SITE PLAN AMENDMENT
FAIRWAY VIEW VILLAGE CONDOMINIUM

FIELDSIDE LANE
WELLS, MAINE

1"=20'
DATE 2/21/22
SHEET 6A

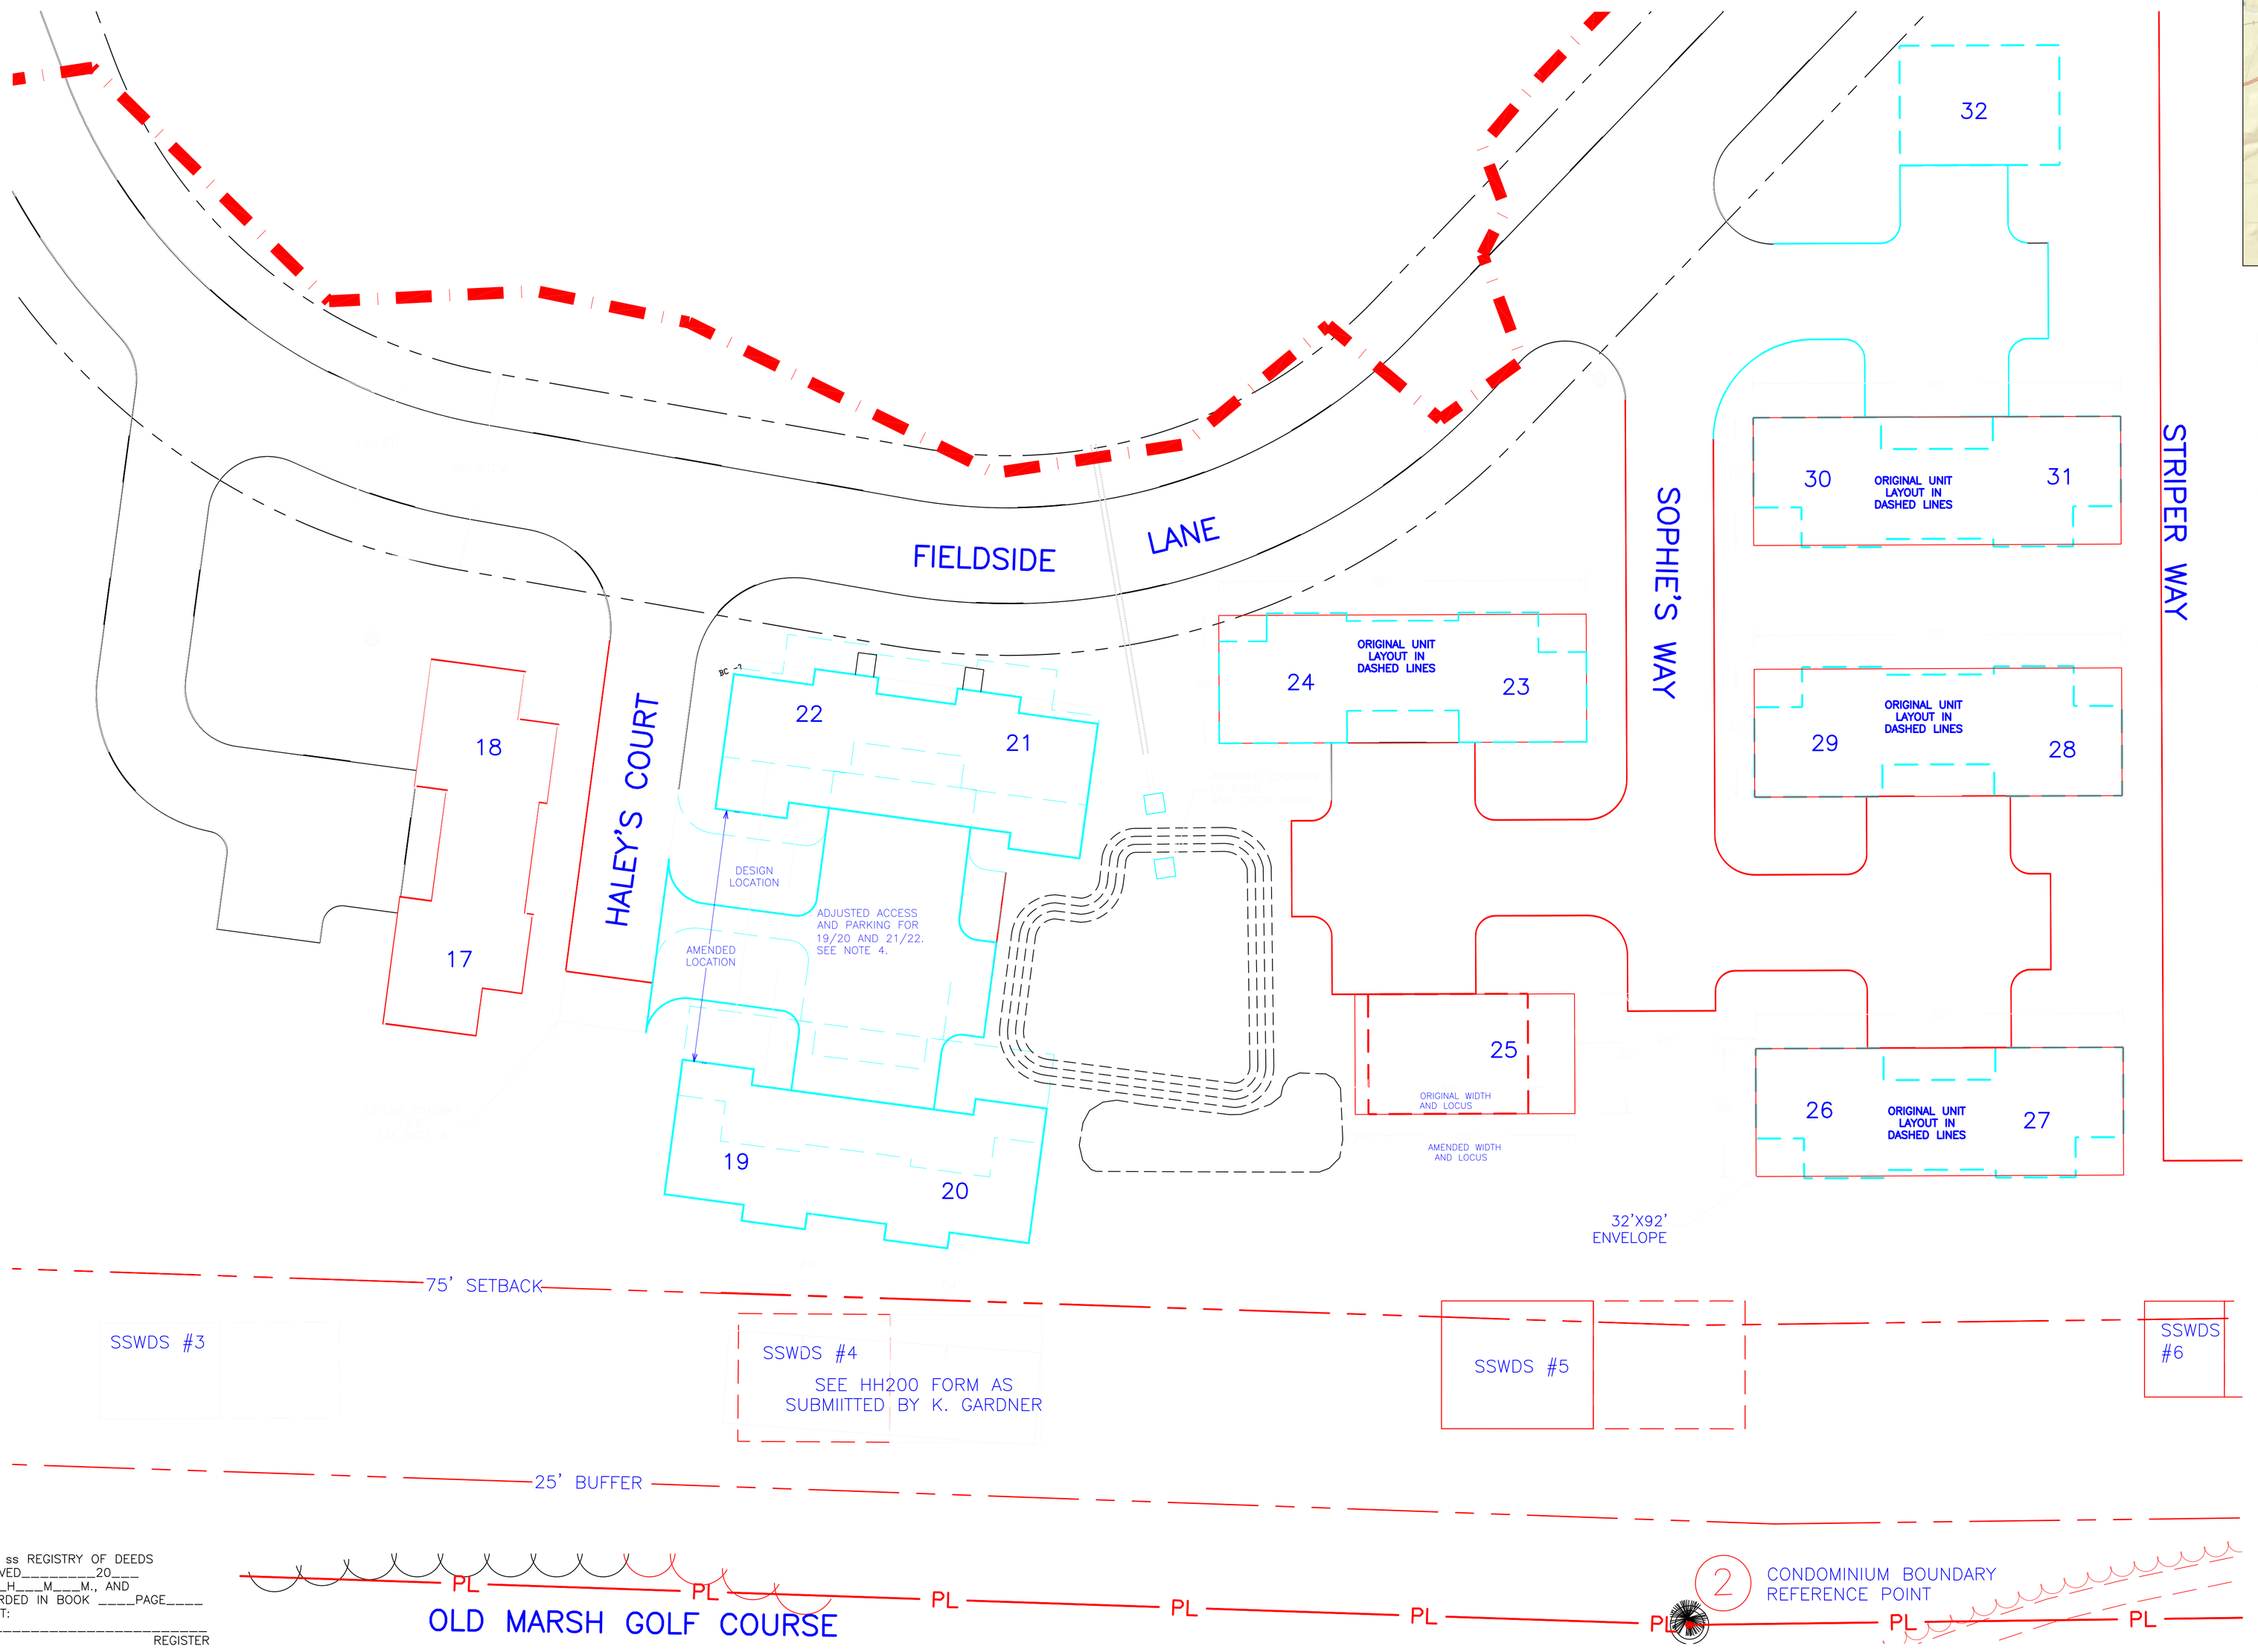
4. THE PURPOSE OF THIS AMENDMENT IS TO:
   - *CREATE A BUILDING ENVELOPE AT EACH UNIT SITE WITHIN WHICH DIFFERENT MODELS MAY BE CONSTRUCTED. THIS ENVELOPE WILL BE APPLIED TO UNITS 23 THROUGH 46.

- *PORTRAY UPDATED AS-BUILT LOCATIONS FOR UNITS 19/20, 20/21, AND THE PROPOSED FULL WIDTH OF 63' FOR THEIR ASSOCIATED ACCESS WAYS AND PARKING AREAS.

- *PORTRAY A REVISED LOCATION OF FILTER POND #6 AND ITS ASSOCIATED STRUCTURES. SEE SHEET 16 OF THE ORIGINAL PLAN SET FOR DETAILS OF POND #6.
   - *PORTRAY A REVISED BUILDING ENVELOPE FOR UNIT #25.

- *EXTEND HAYLEYS COURT BY 12.6' TO ACCOMODATE THE NEW LOCATION OF UNITS 19/20 AND 21/22.
5. THE AMENDED POSITIONS AND DIMENSIONS OF UNITS 19/20 AND 21/22, AND THE NECESSARY EXTENSION OF HALEY'S COURT WILL RESULT IN A NET INCREASE IN IMPERVIOUS AREA OF 1,303 S.F.
